THE GARDENS AT NORTH CAREFREE  
PUD DEVELOPMENT/  
PRELIMINARY PLAN  
El Paso County, CO

FINAL  
LANDSCAPE PLAN

7  
OF 10

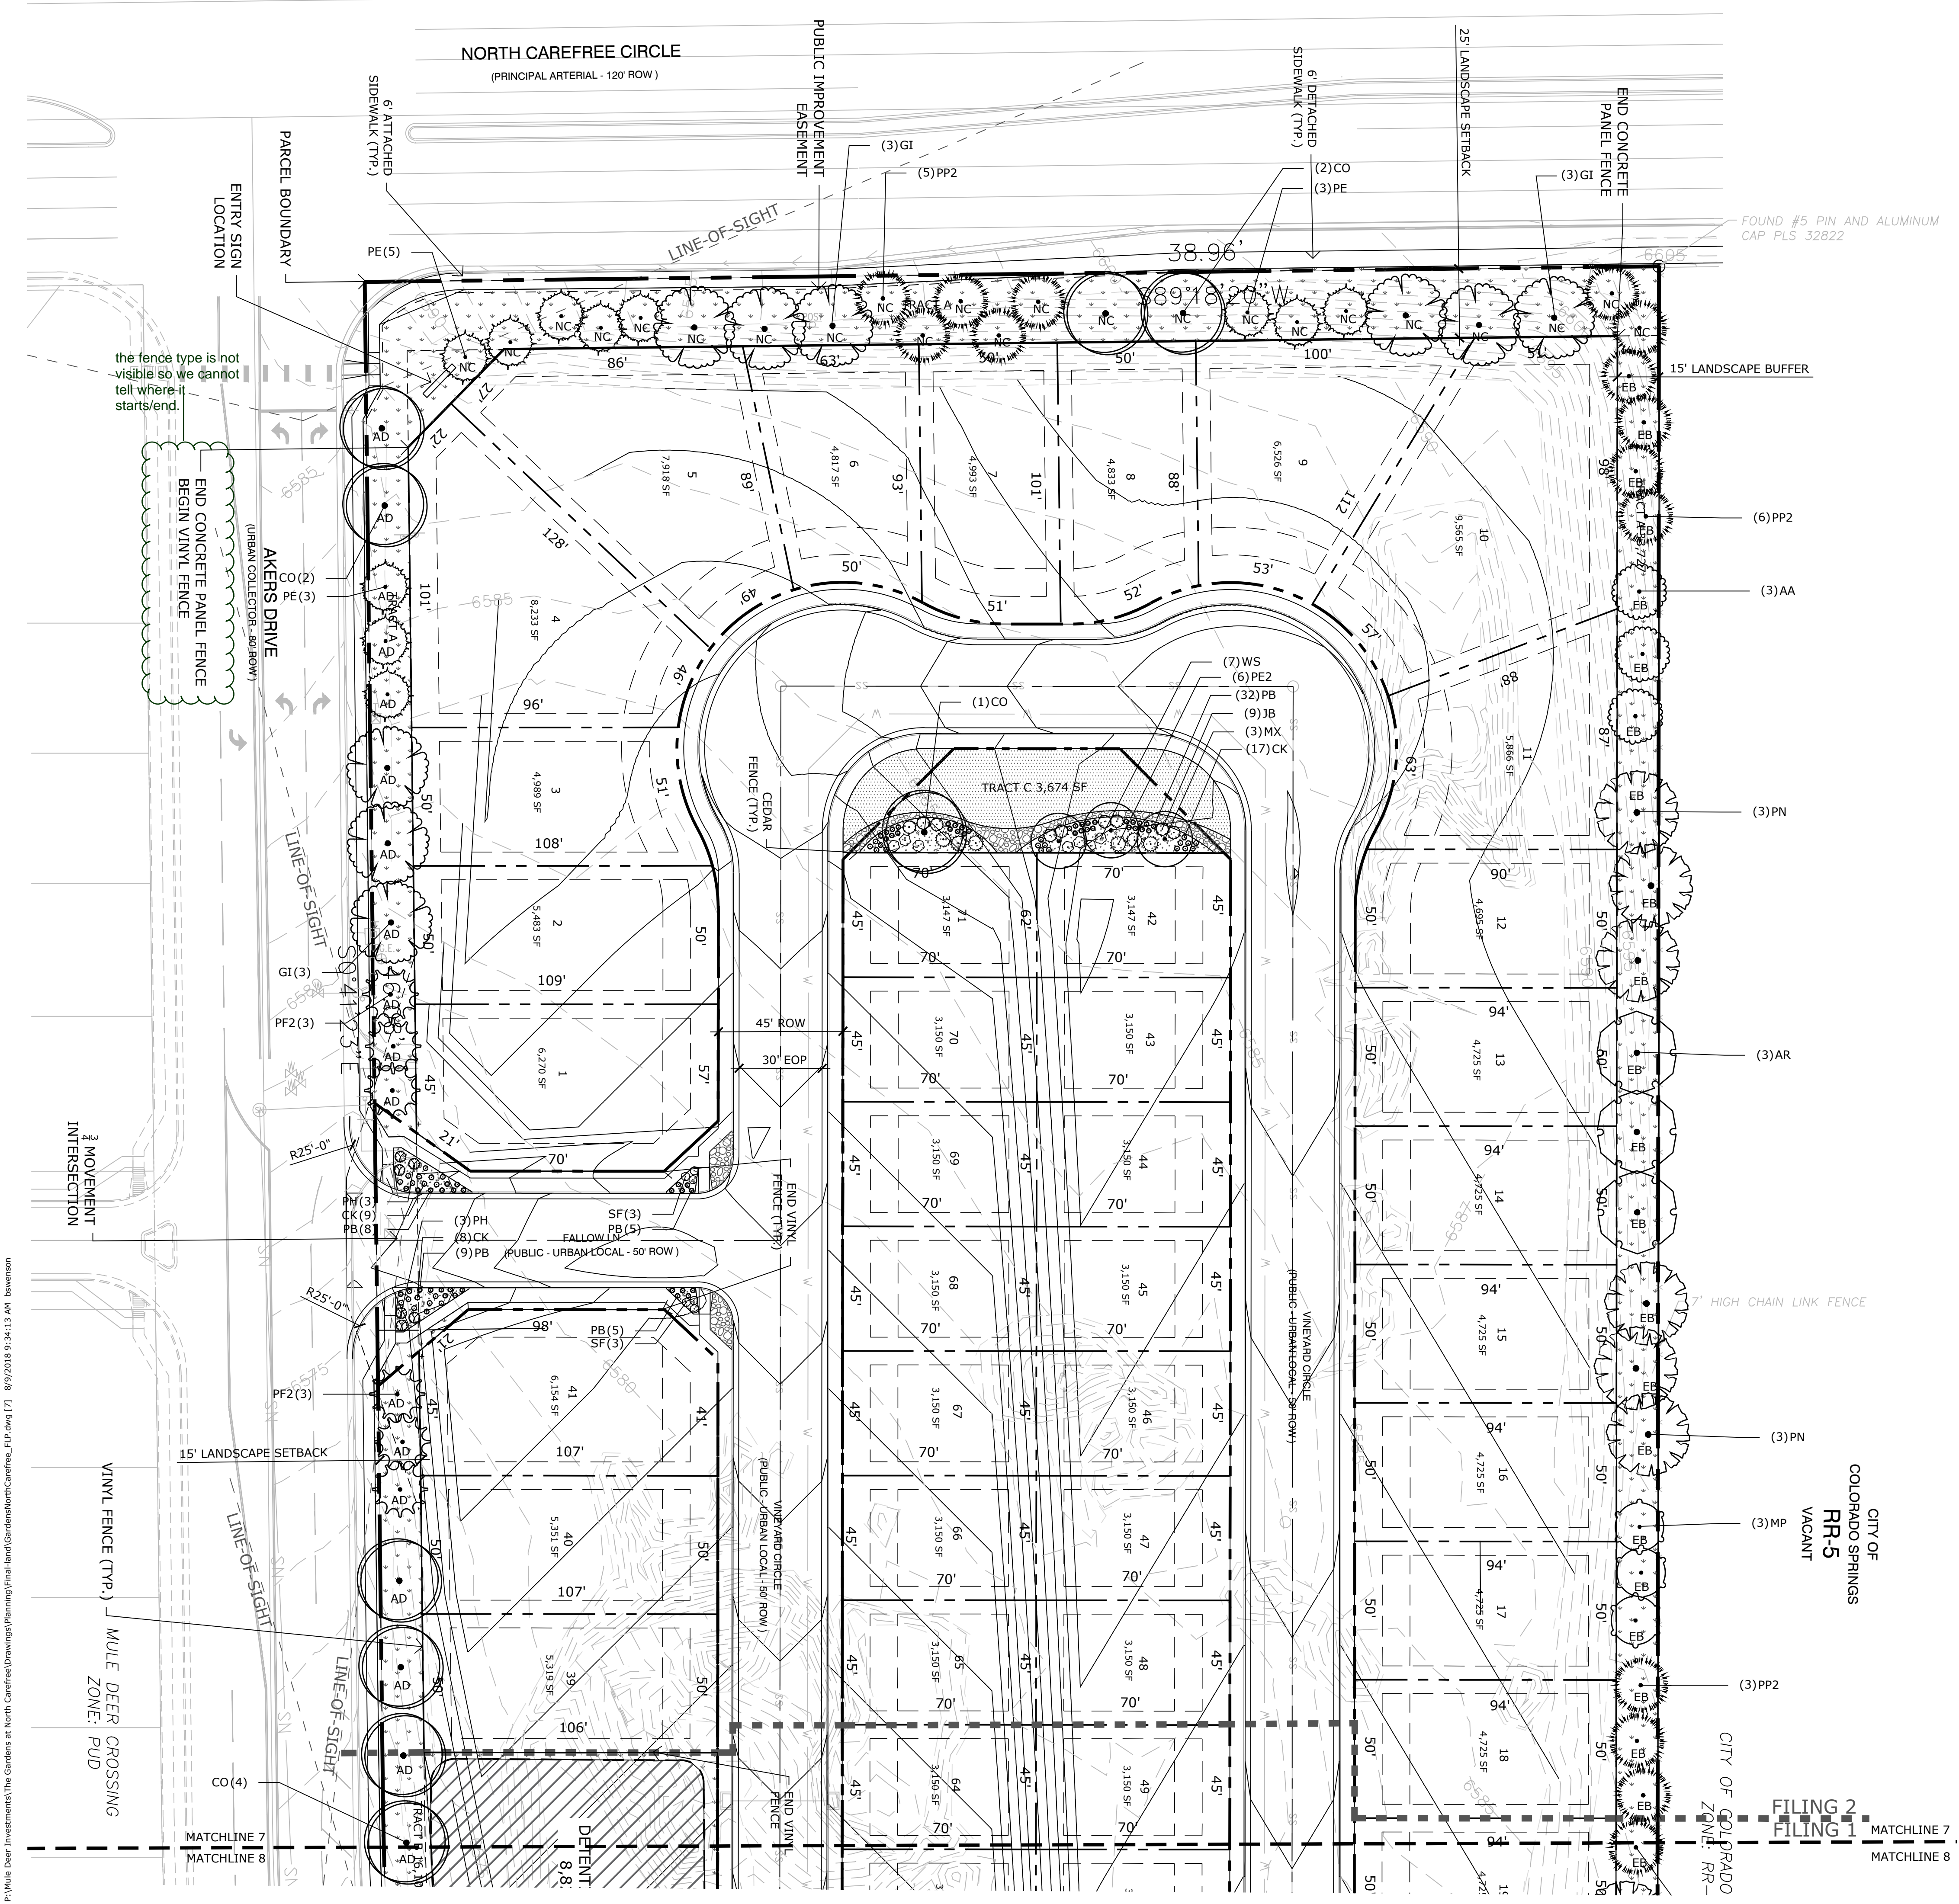
the fence type is not visible so we cannot tell where it starts/end.
